UNITED STATES PATENT AND TRADEMARK OFFICE

APPLICATION NO.	FILING DATE	FIRST NAMED INVENTOR	ATTORNEY DOCKET NO.	CONFIRMATION NO.
10/085,738	02/28/2002	Kevin S. Weadock	15314 (ETH-1636)	8872
<div>7590 Scully, Scott, Murphy & Presser 400 Garden City Plaza Garden City, NY 11530</div>			<div>EXAMINER EREZO, DARWIN P</div>	
			<div>ART UNIT 3773</div>	<div>PAPER NUMBER</div>
			<div>MAIL DATE 11/14/2007</div>	<div>DELIVERY MODE PAPER</div>

Office Action Summary

DETAILED ACTION

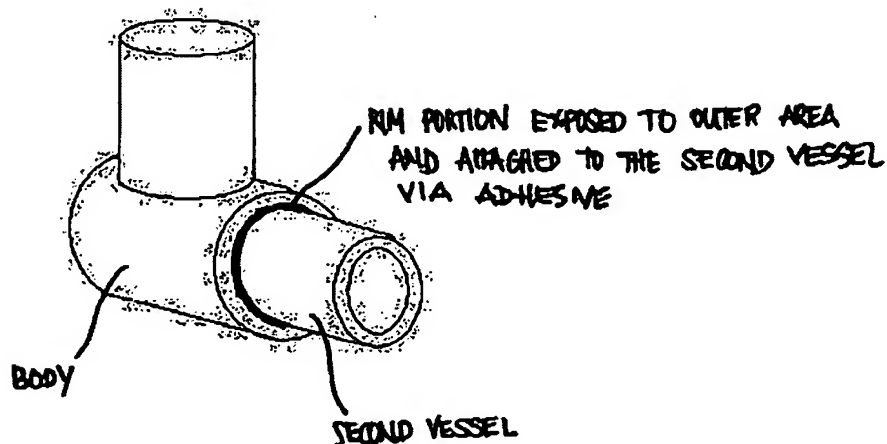
The applicant amended the claims to recite the limitation "the outer surface forms the outer profile of the body". It was then argued that Lyer fails to disclose a second securing means which secures a portion of the second vessel to a corresponding portion of the outer surface forming the outer profile of the body" (page 12 of remarks). However, this is not persuasive because the invention of Lyer still anticipates the amended limitation.

As stated in the rejections above and shown in the figure below, Lyer discloses the device having the following:

-an outer surface (any external surface) having a portion that defines the outer profile of the device,

-another "portion" of the outer surface (external surface) being attached to the second vessel.

As stated in the claims, only a "portion" of the outer surface is secured to the second vessel. It does not specify which portion of the outer surface is secured to the second vessel. Therefore, it is the examiner's position that the device of Lyer has an outer surface having a portion that defines the outer profile of the device and another portion being secured to the second vessel.

It should also be noted that the limitation of the outer surface defining an outer profile of the body does not impose any specific structural limitations to the device. That is, any portion of the outer surface can impose an outer profile of the device, even the edge shown in the illustrated figure below.
